City of Detroit  
Inter-Departmental Communication

**RE:** Petition No. 934  
Requested Encroachment into a Portion of Dequindre Ave. in the Area Bound by  
Rivard, Cherboneau Place, St. Aubin, and East Lafayette Blvd.

**NOTICE OF PROPOSED CHANGE IN PROPERTY**

REQUEST ENCROACHMENT  
 A PORTION OF DEQUINDRE AVE.  
 VARIOUS WIDTHS IN THE AREA BOUND BY  
 RIVARD ST., CHERBONEAU PLACE, ST. AUBIN AVE.  
 AND E. LAFAYETTE BLVD.  
 (With Performance Space)

JOB NO. 01-01  
 DRWG. NO. X 934

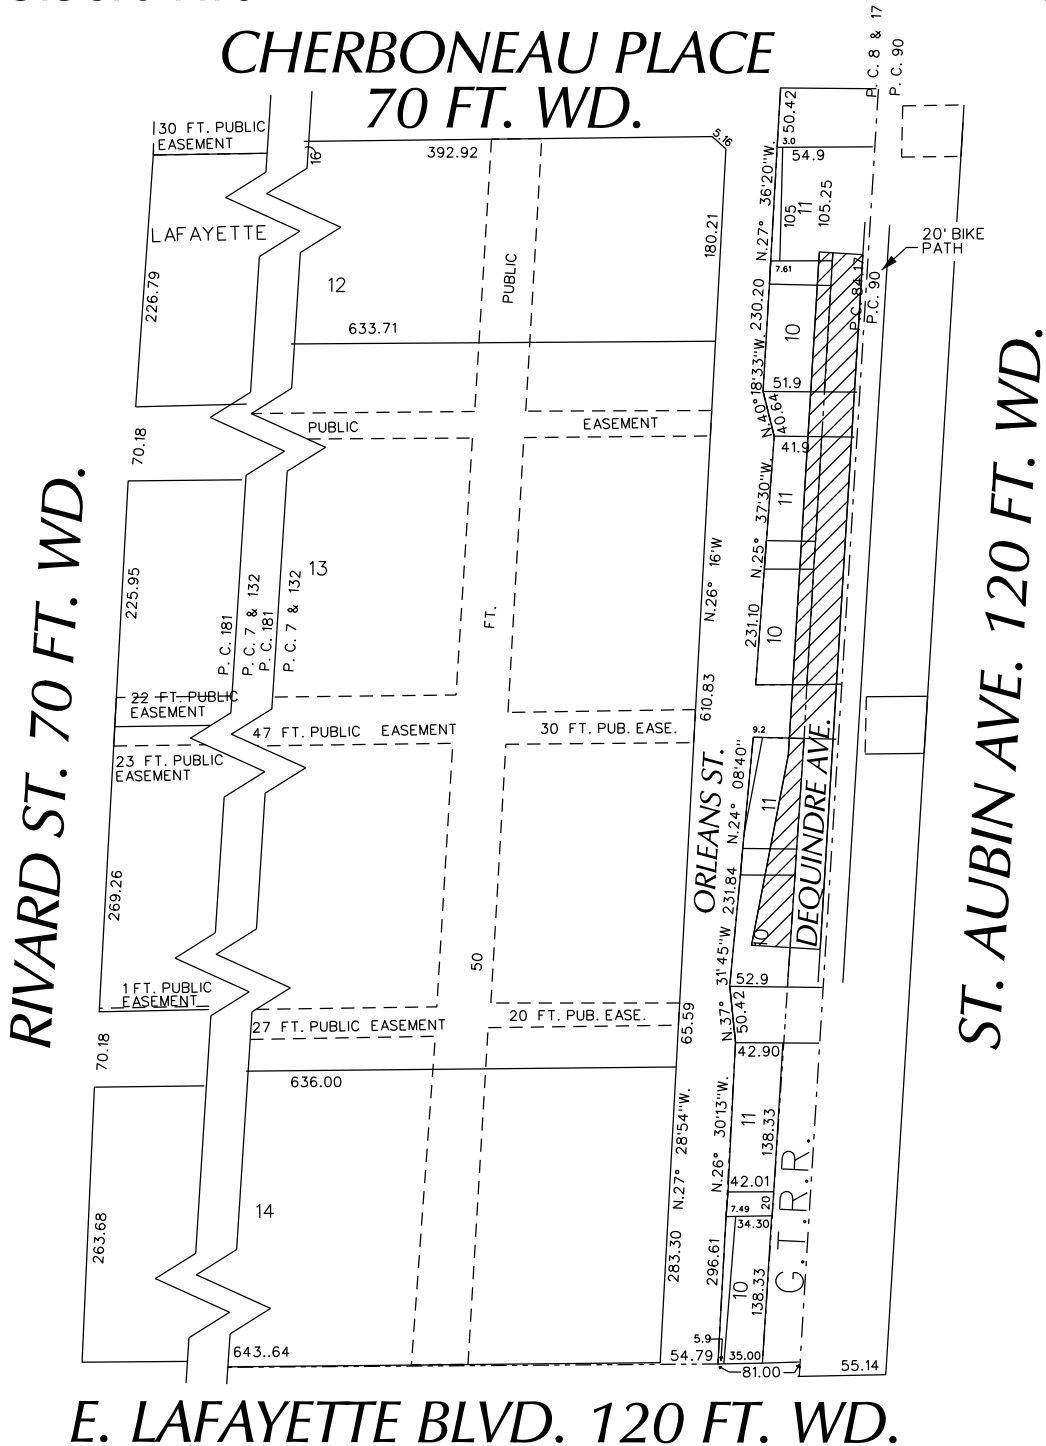
- Our records indicate that there are water mains in the area of encroachments. DWSD has no objection to the requested encroachments provided that the attached Provisions for Encroachment are strictly followed.

Detroit Water and Sewerage (DWSD) agree to the proposed encroachment subject to the fulfilling of the following provisions:

1. By approval of this petition the (DWSD) does not waive any of its rights to its facilities located in the right of way, and at all time, DWSD, its agents or employees, shall have the right to enter upon the right of way to maintain, repair, alter, service, inspect, or install its facilities. All costs incident to the damaging, dismantling, demolishing, removal and replacement of structures or other improvements herein permitted and incurred in gaining access to DWSD's facilities for maintenance, repairing, alteration, servicing or inspection caused by the encroachment shall be borne by the petitioner. All costs associated with gaining access to DWSD's facilities, which could normally be expected had the petitioner not encroached into the right of way shall be borne by DWSD.

2. All construction performed under this petition shall not be commenced until after five (5) days written notice to DWSD. Seventy-two (72) hours notice shall also be provided in accordance with P.A. 53 1974, as amended, utilizing the MISS DIG one call system.

3. Construction under this petition is subject to inspection and approval by DWSD forces. The cost of such inspection shall, at the discretion of DWSD, be borne by the petitioner.

4. If DWSD facilities located within the right of way shall break or be damaged as the result of any action on the part of the petitioner, then in such event the petitioner agrees to be liable for all costs incident to the repair, replacement or relocation of such broken or damaged DWSD facilities.

5. The petitioner shall hold DWSD harmless for any damage to the encroaching device constructed or installed under this petition, which may be caused by the failure of DWSD's facilities.
